ADDENDUM NUMBER I

DATE: February 9, 2026

PROJECT: Newark Valley Central School District 2023
Capital Project – Phase III
High School Air Conditioning

1 SECOND FLOOR POWER PLAN - AREA 3 UPPER
E407-AD1 1/8" = 1'-0"

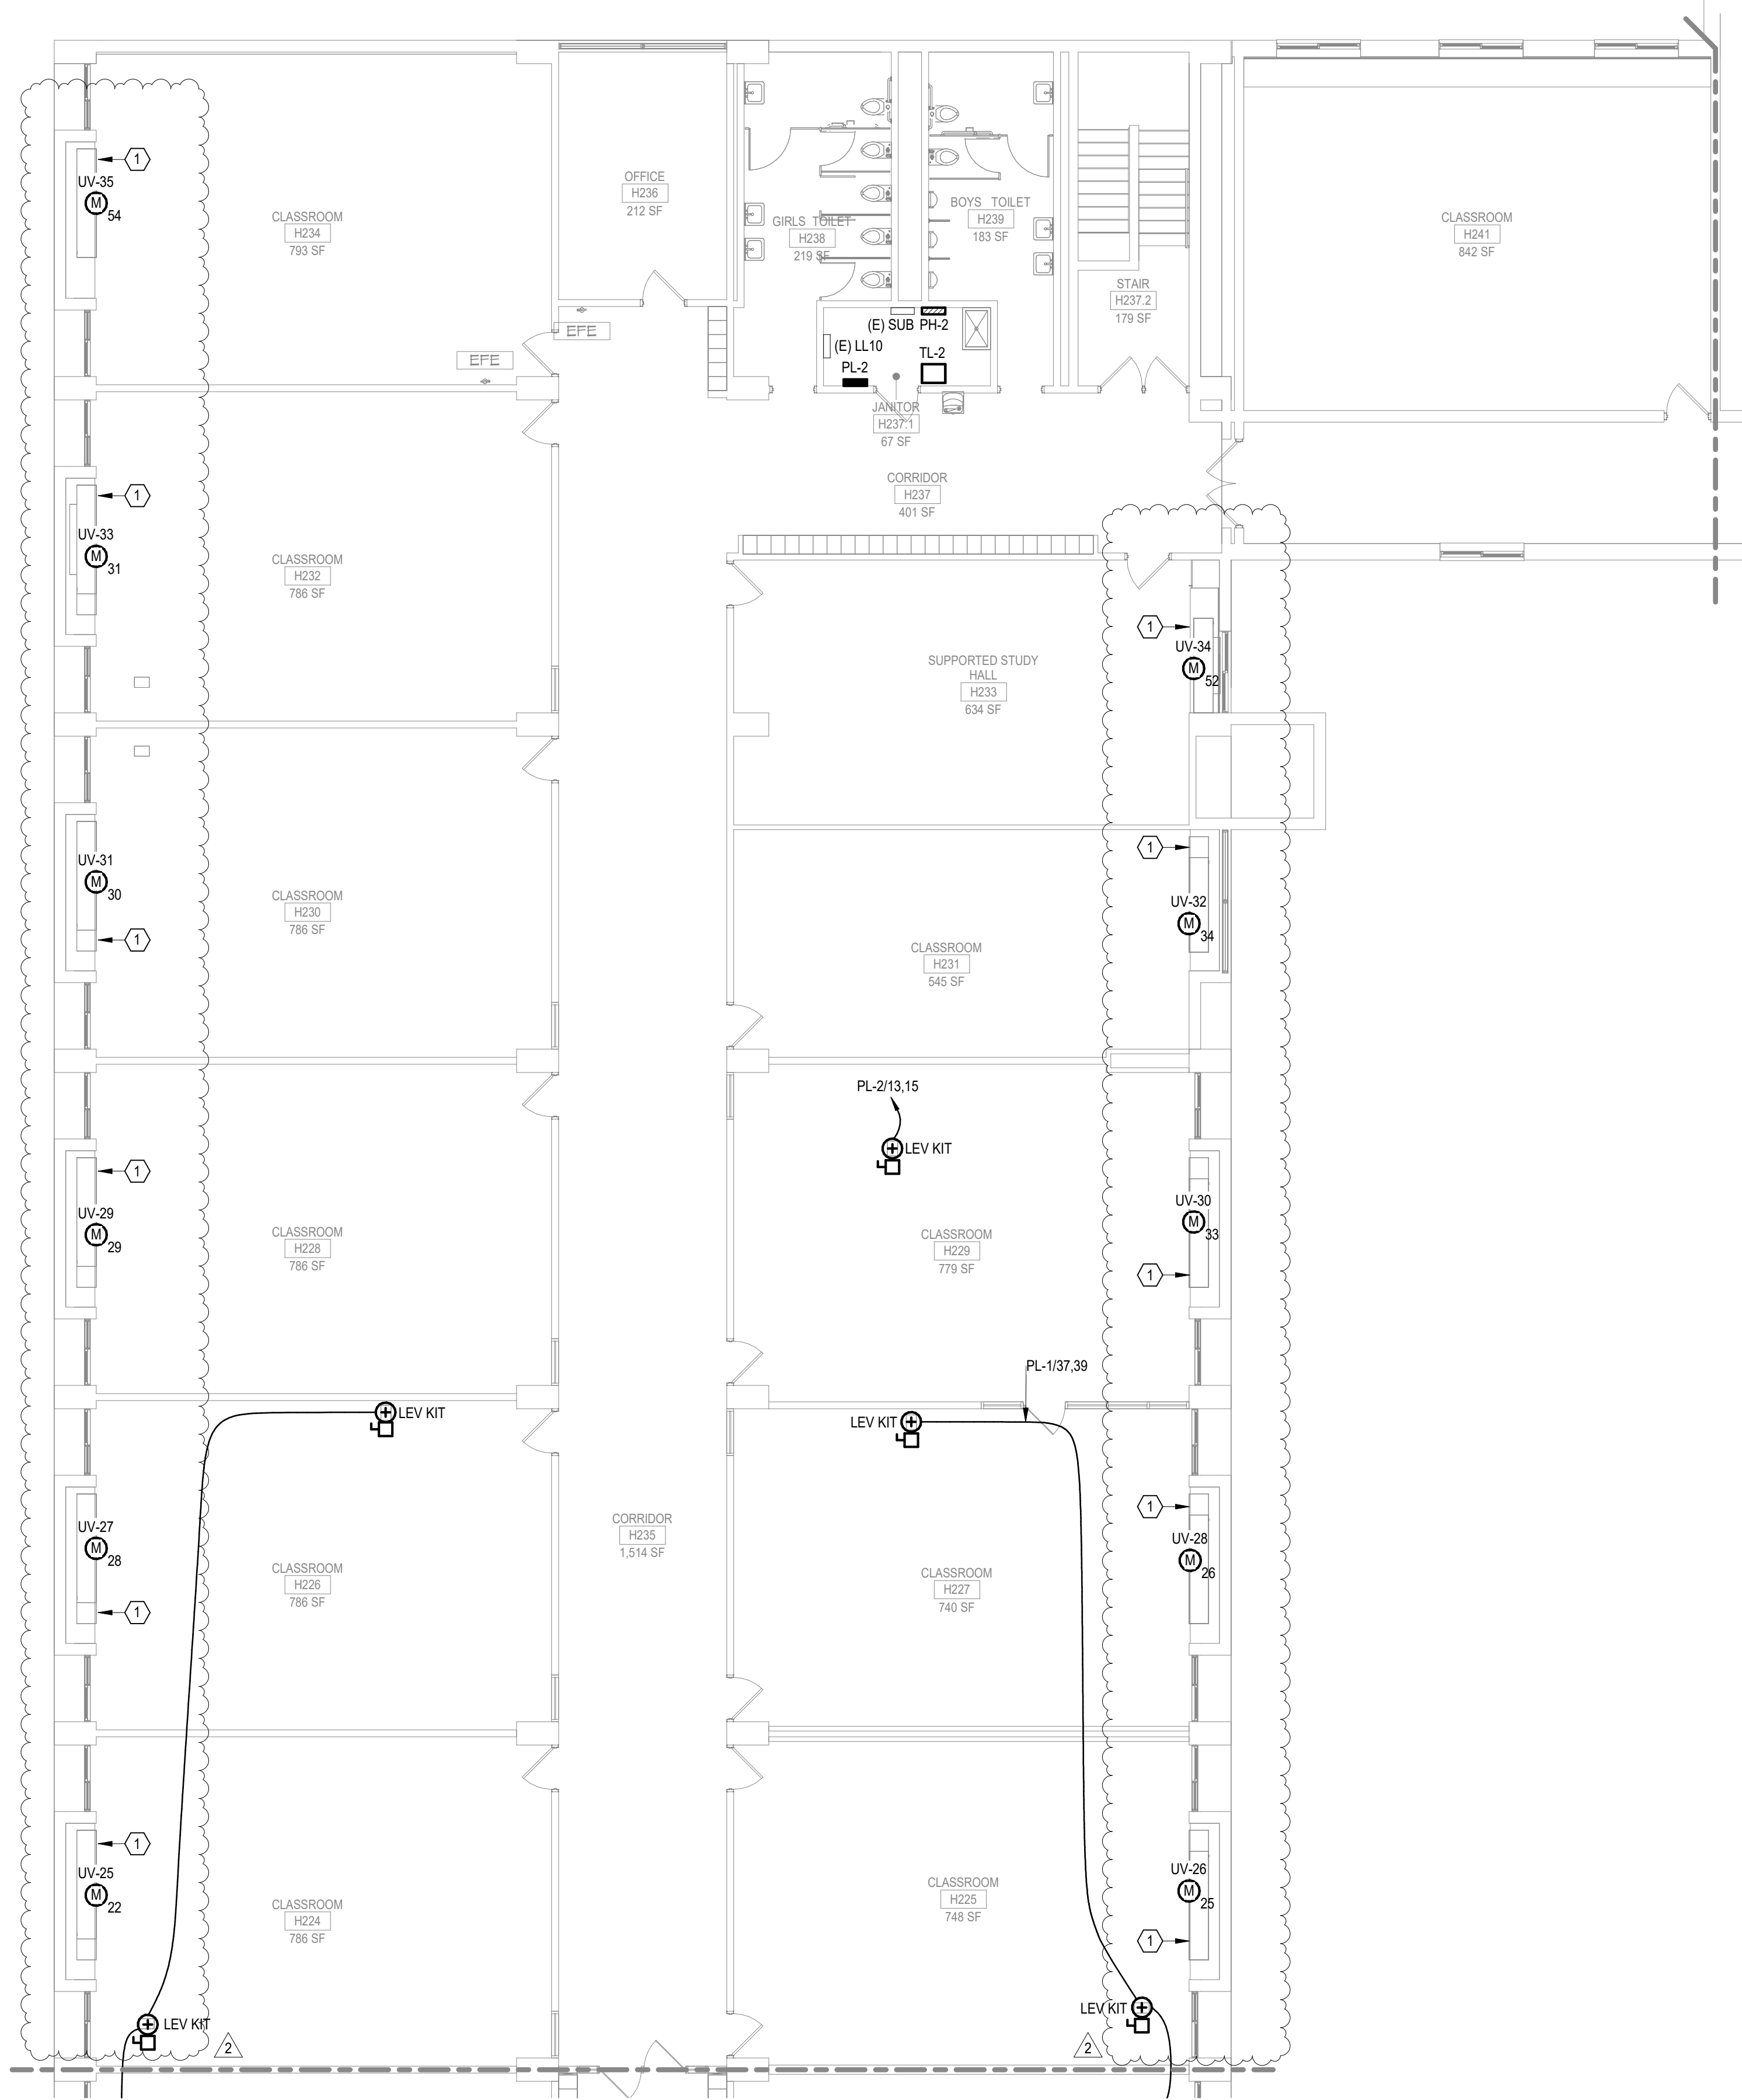
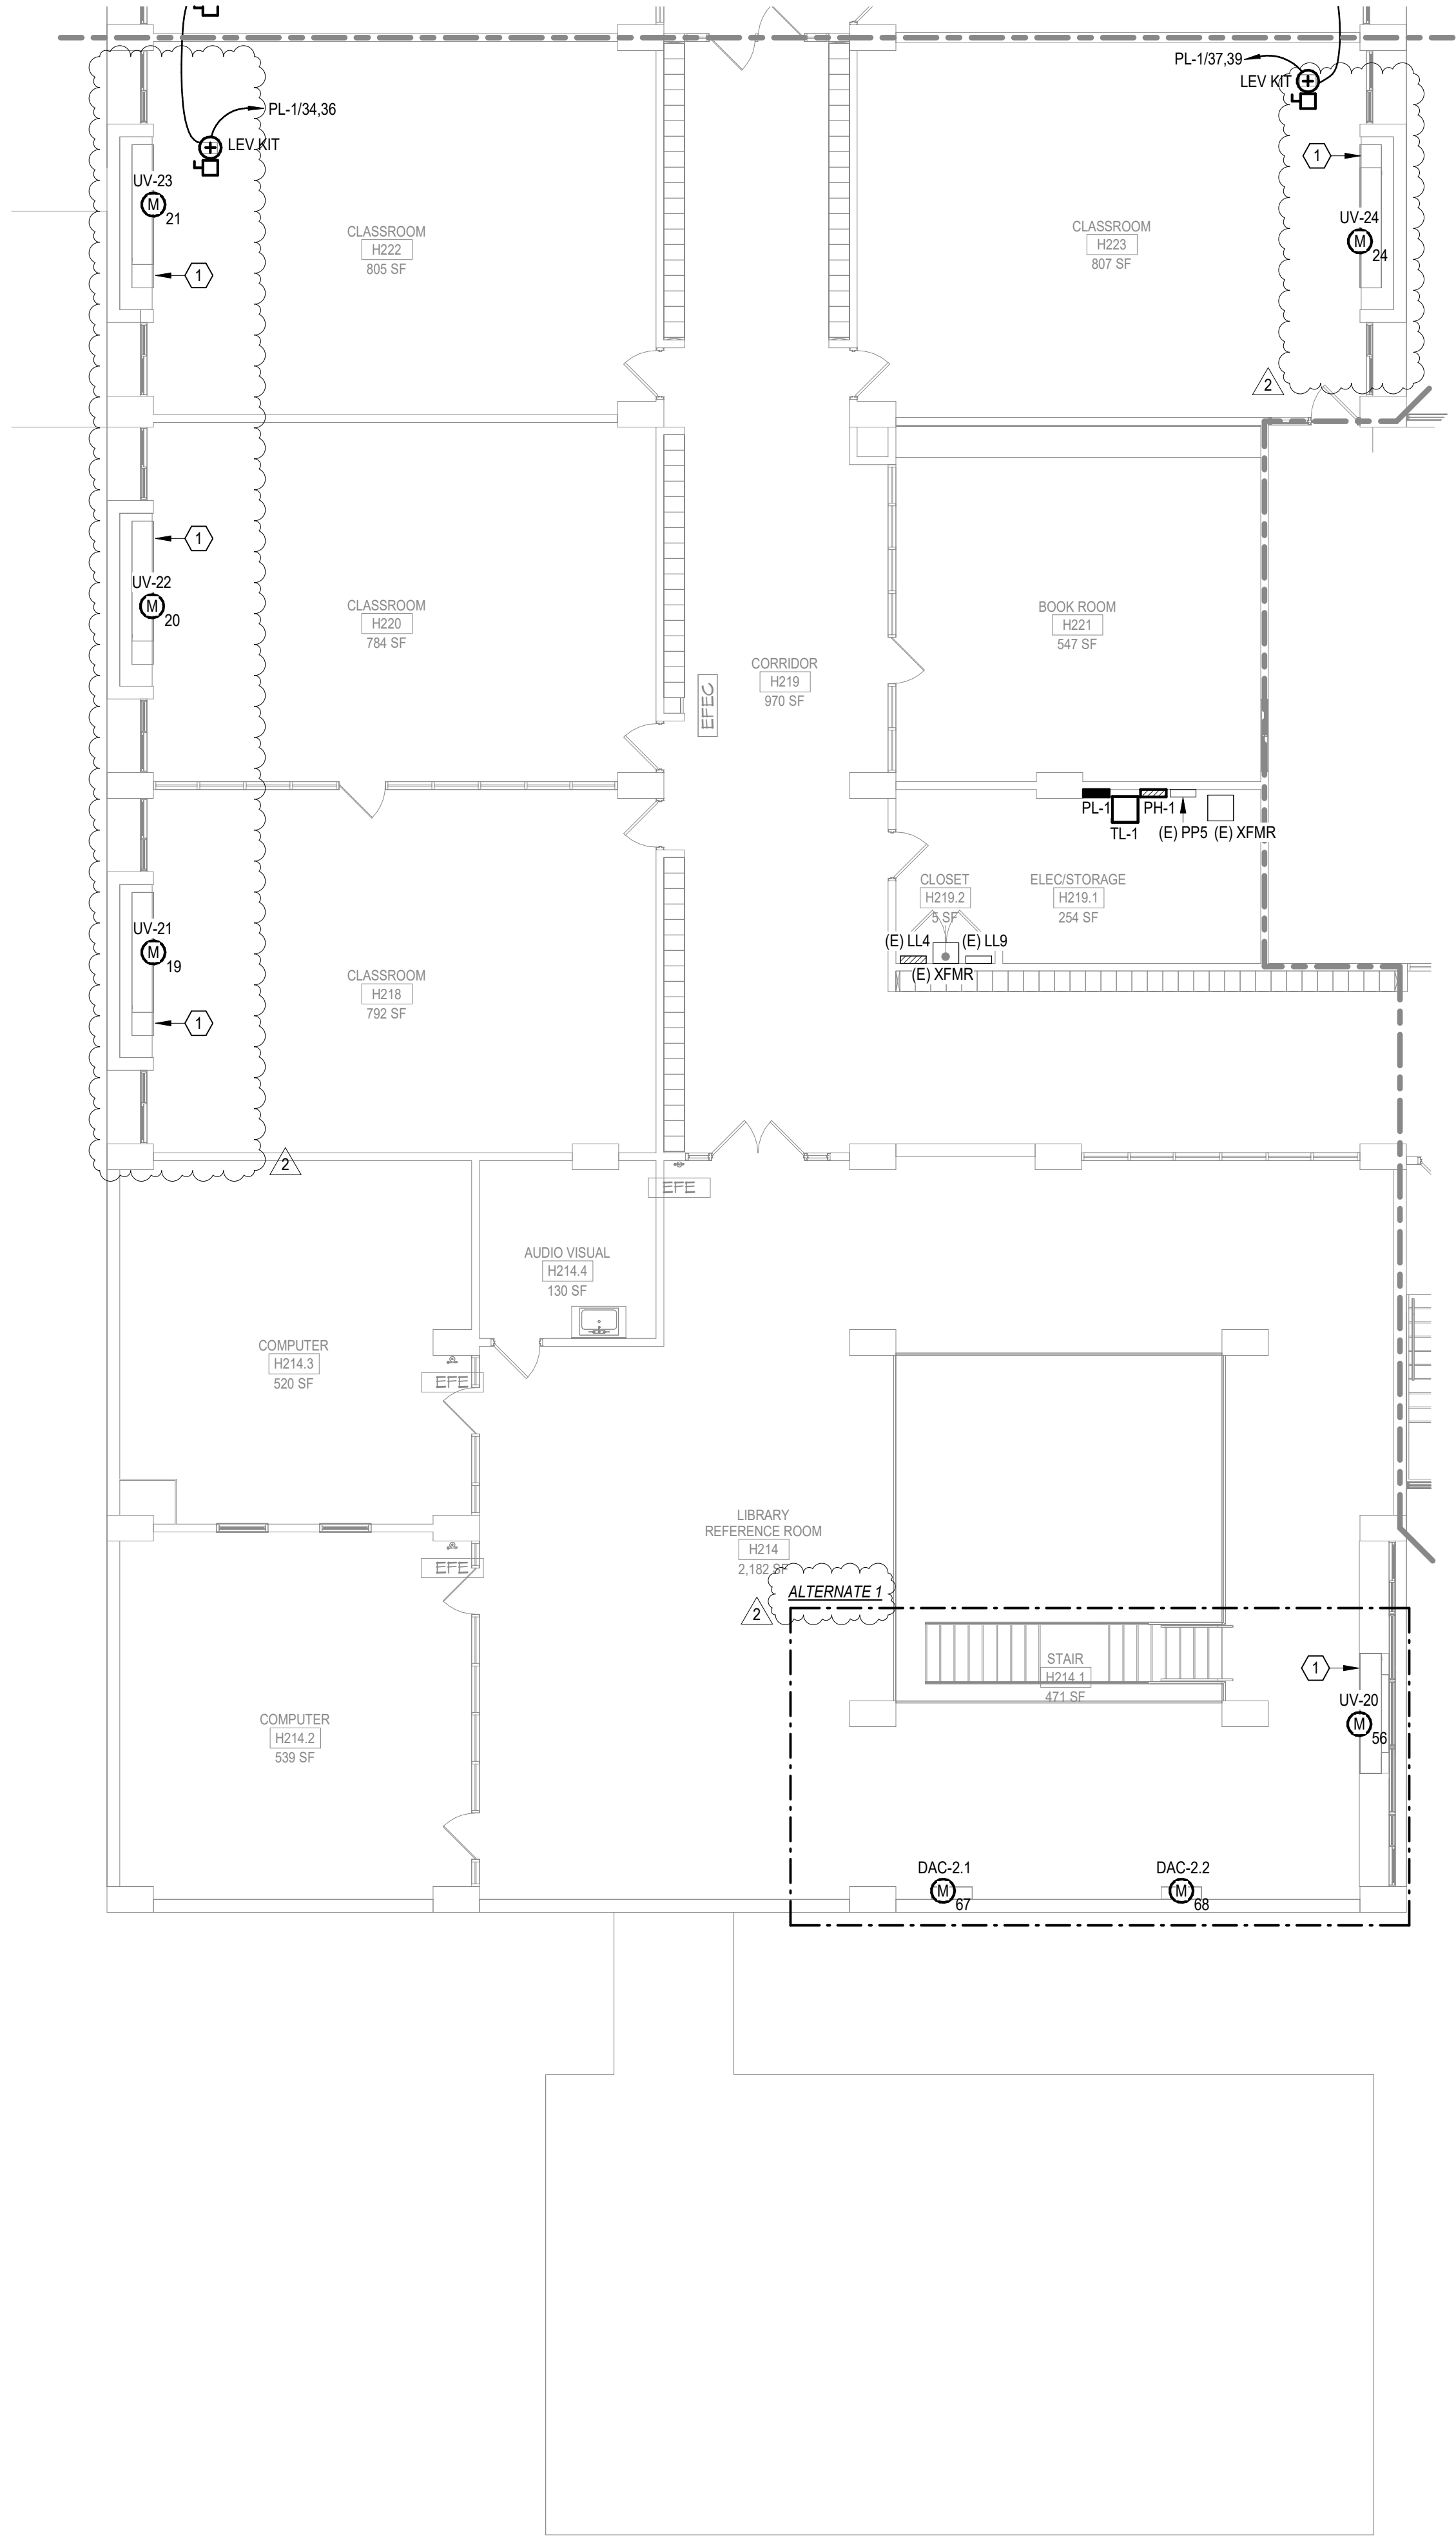
39. E407 - SECOND FLOOR POWER & SYSTEMS PLAN - AREA 3

- a. REVISE as shown on the attached drawing E407-AD I.
